**LPI, Inc. Consulting Engineers**

*Advanced Analysis & Fitness for Service  
Failure & Materials Evaluation  
Nondestructive Engineering*

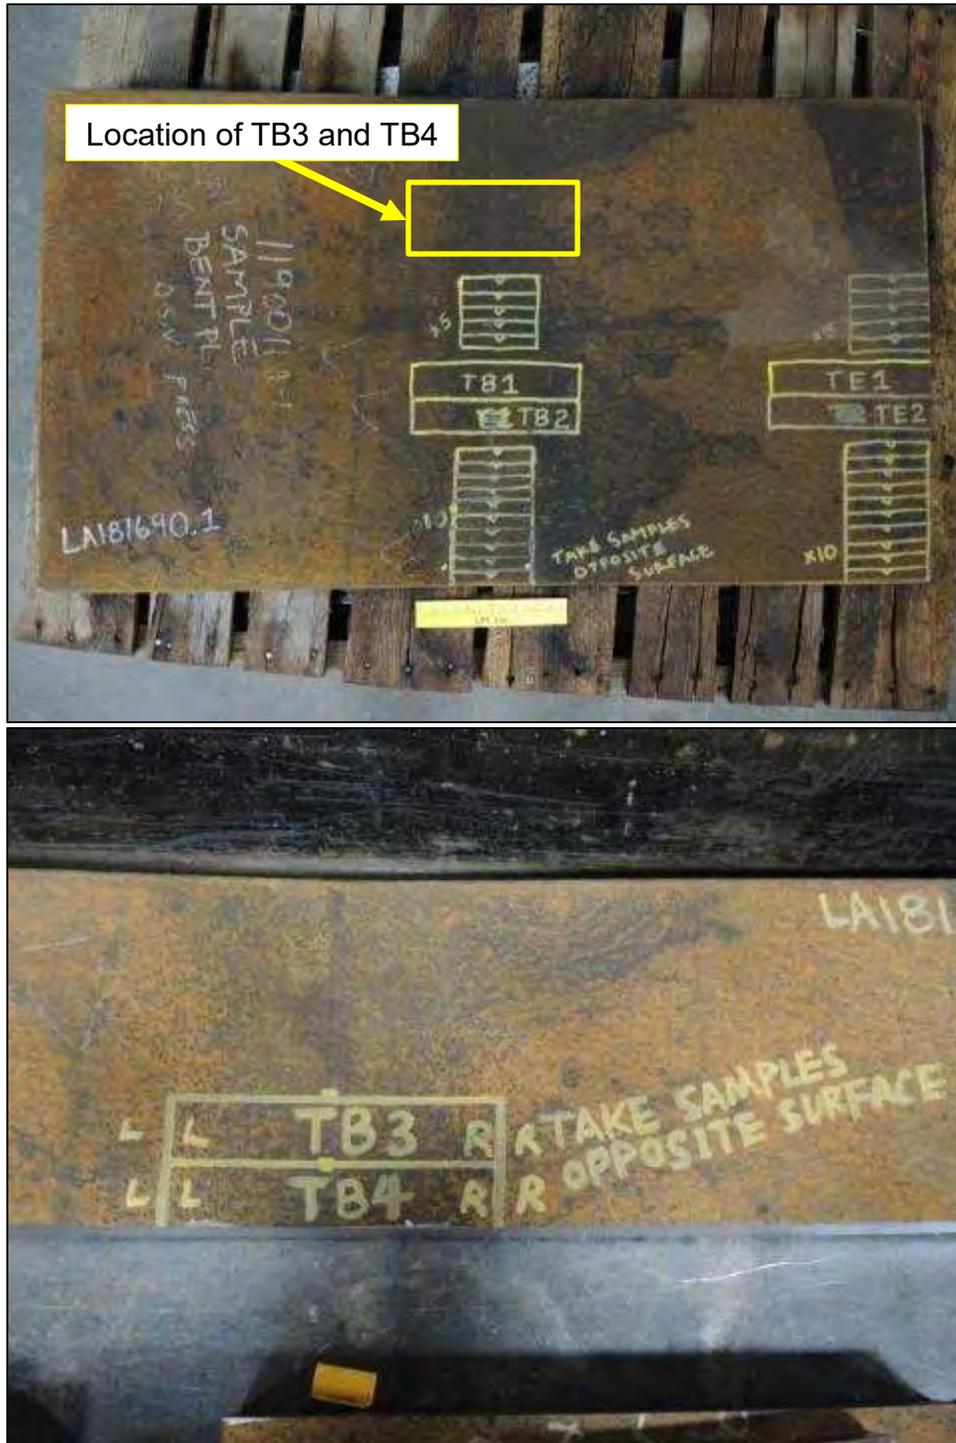
Fig. 122. Tensile and CVN specimen location mark-up prior to sectioning.
